SUBJECT: Forwards response to IE Bulletin 80-11, "Masonry Wall
 Design," supplementing response to NRC 820805 request for
 addl info. (See Repts)

Re: St. Lucie Unit 1
Docket No. 50-335
IE Bulletin 80-11
Additional Information

ST LUCIE PLANT - UNIT 1
IE BULLETIN 80-11: MASONRY WALLS
NRC REQUEST FOR ADDITIONAL INFORMATION

FINITE ELEMENT MODEL

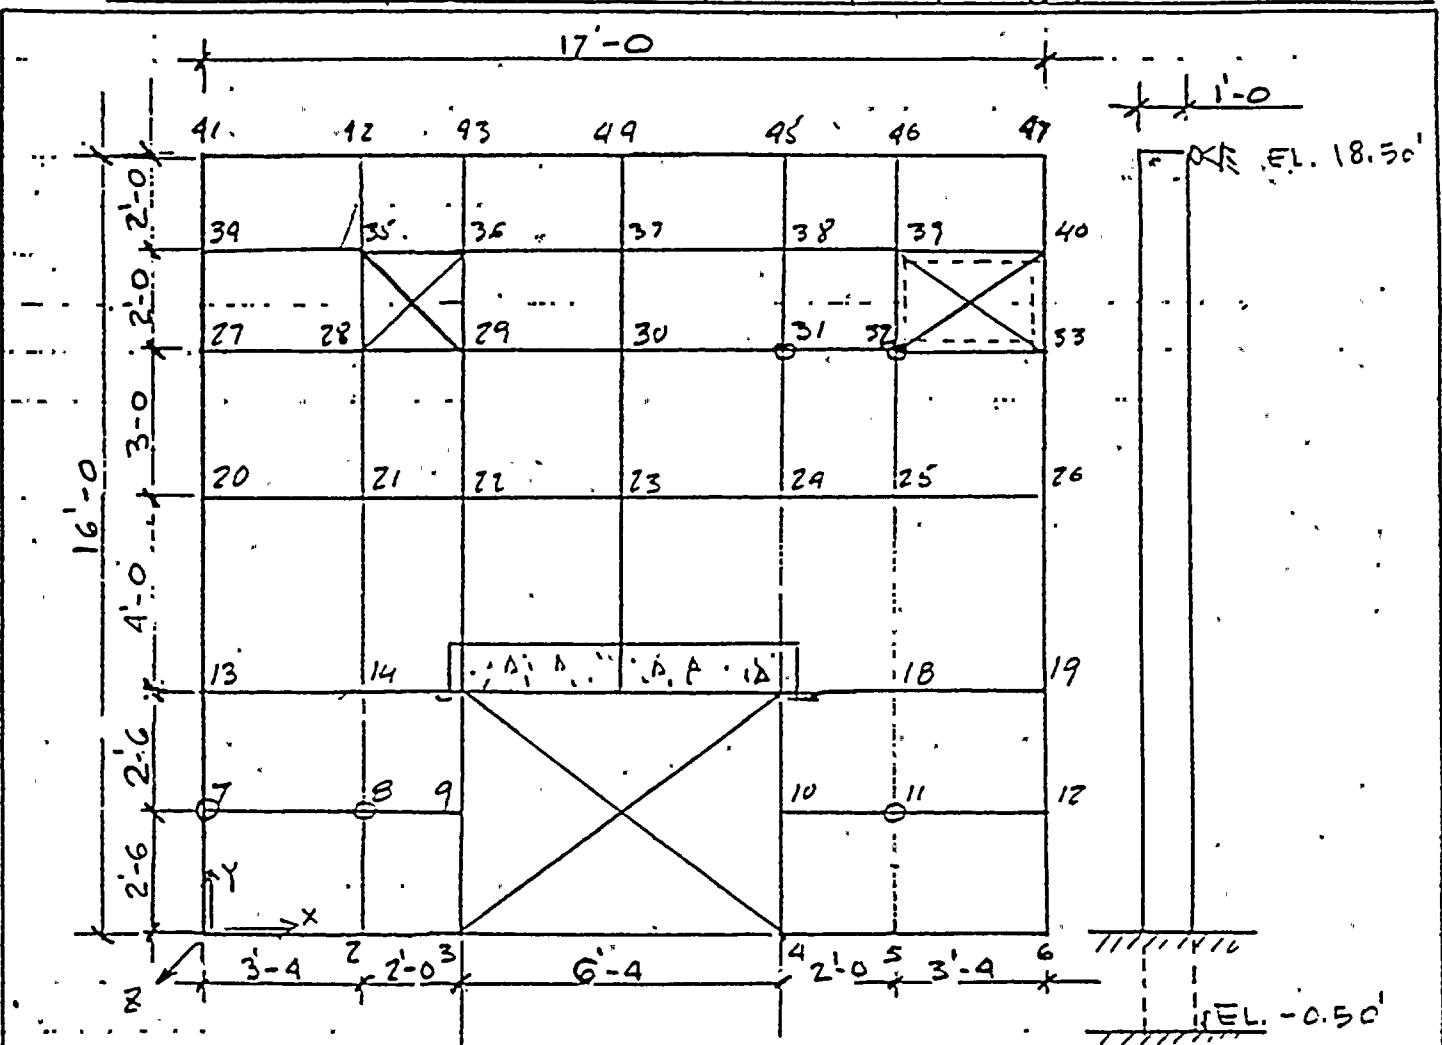
Provide a sample drawing of a finite element model to illustrate how openings and attachments were considered in the model.

Response:

A sample drawing of a finite element model to illustrate how openings and attachments were considered in the model is provided in Attachment A.

BY C. SHIH DATE 1/14/81CHKD. BY J. D. NAIUS DATE 1/21/81SHEET 193 OF 204DEPT.
NO. 5ECCLIENT FLOPROJECT ST LUCIE #1 NRC IE BULLETIN 80-11SUBJECT MASONRY WALL RE-EVALUATION - WALL NO 114, PROPOSED FIXWALL NO 114.

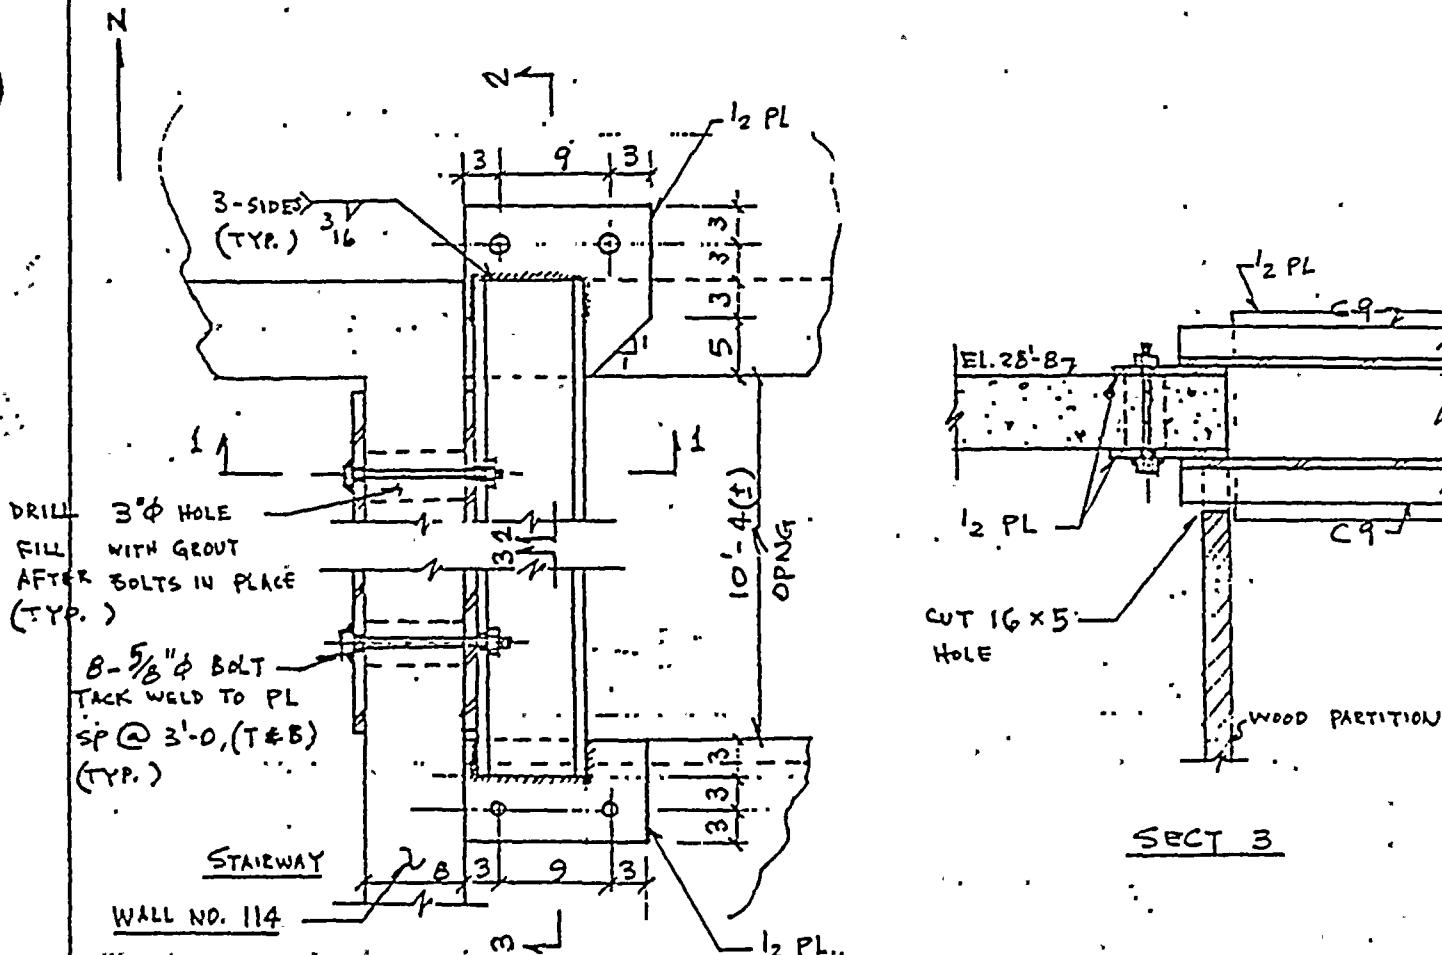
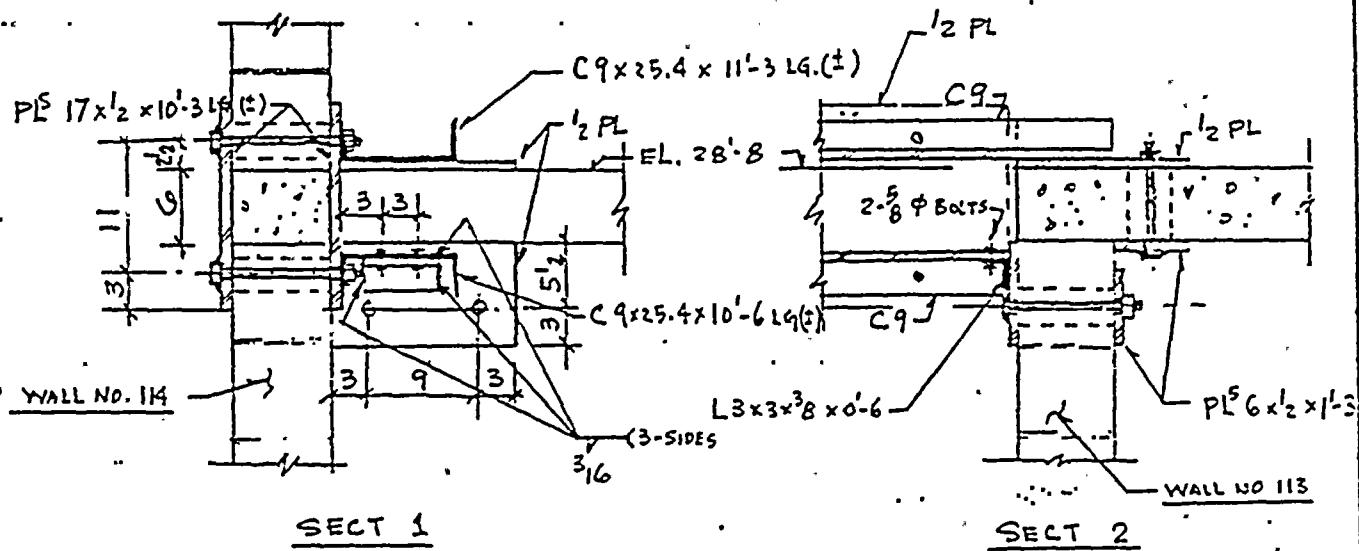
Provide sample drawings of wall modifications, and clarify whether the modified walls were qualified under working stress conditions.

Response:

The sketches of wall modification (wall No. 114) are included in Attachment D. All modified walls are qualified under working stress conditions.
